## **LAND DEVELOPMENT CODE ADVISORY COMMITTEE**

**MINUTES REPORT**  
**LAND DEVELOPMENT CODE ADVISORY COMMITTEE**  
**(LDCAC)**  
**Friday, February 13, 2026**  
**8:30 a.m.**

**MEMORANDUM**

**RE: Land Development Code (LDC) Amendments**  
*Architectural Requirements, Administrative Deviations, Industrial Use of Shipping Containers, Administrative Amendments to Existing Mines, Clean-up*

**Illustration 4**

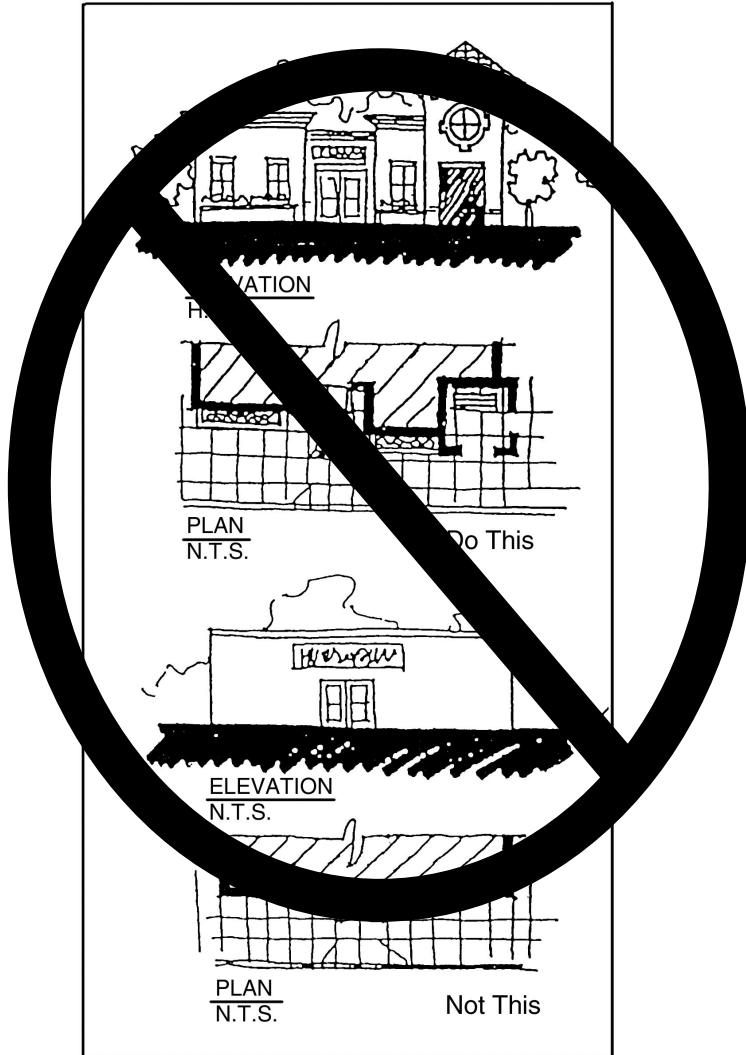
*Staff note: Eliminated specific illustrations and examples to prevent restrictions on improvements and to allow design consultants increased flexibility in developing project-appropriate solutions. Allow lesser requirements for minor commercial development and redevelopment of existing commercial properties.*

- (a) *Purpose and intent.* The purpose and intent of these provisions is to maintain and complement the street scape by requiring that buildings be designed with architectural features and patterns that provide visual interest, consistent with the community's identity and local character while reducing the mass/scale and uniform monolithic appearance of large unadorned walls. (See Illustration 4 below.)

**Illustration 6**

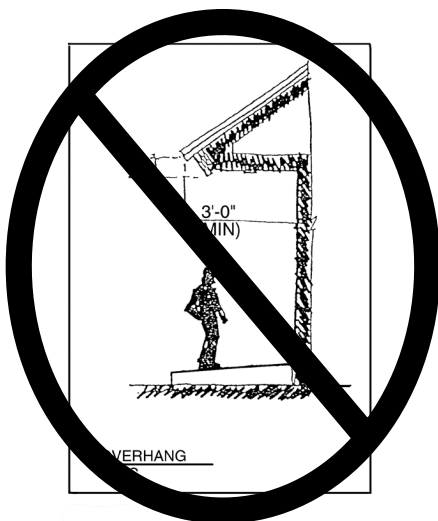
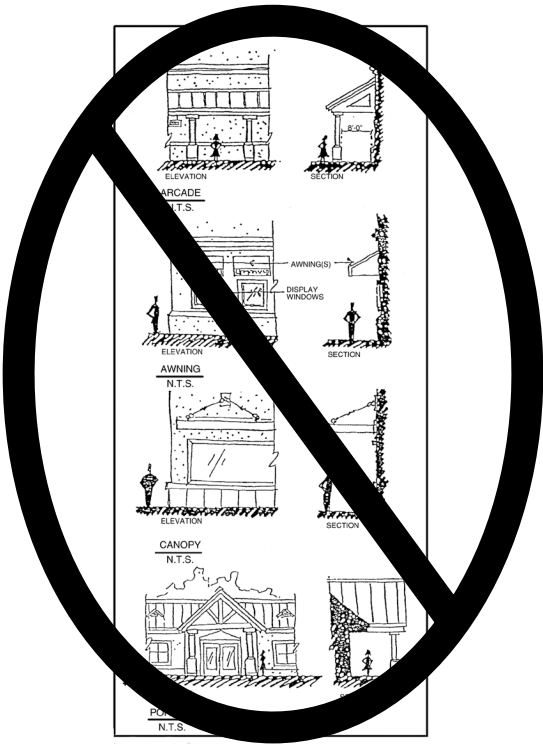
- b. Buildings must provide a minimum of three of the following building design treatments integrated with the massing and style of the buildings. (See Illustrations 6 and 7 below.) If awnings, canopies and overhangs are used they must conform to a unified plan of compatible colors, shapes and materials. Minor commercial, renovations and redevelopment must provide a minimum of two design treatments. These treatments must be demonstrated and called out on the architectural elevation drawings. Examples include but are not limited to:

**Illustration 8**

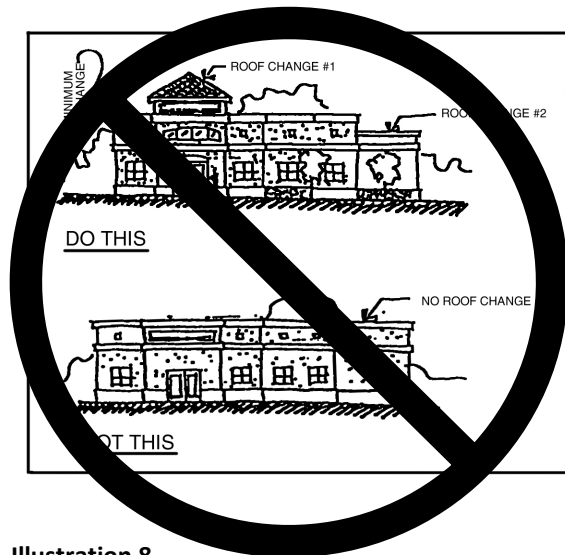
- (1) *Purpose and intent.* Variations in rooflines must be used to add interest to and reduce the massing of buildings. Roof features and materials must be in scale with the building's mass and complement the character of adjoining and/or adjacent buildings and neighborhoods. The following standards identify appropriate roof treatments and features.
- (2) *Roof edge and parapet treatment.* The roof edge and/or parapet must have a vertical change from the dominant roof ~~condition~~ elevation, in two locations. At least one such change must be located on a primary facade. (See Illustration 8 below.) Minor commercial, renovations and redevelopment must provide at least one vertical change on the primary façade(s).

**Illustration 10**

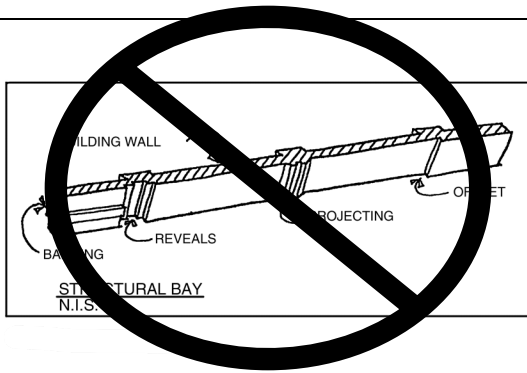
- a. Texture change;
  - b. Material change;
  - c. Architectural features such as bandings, bays, reveals, offsets, or projecting ribs. ~~(See Illustration 10 below);~~
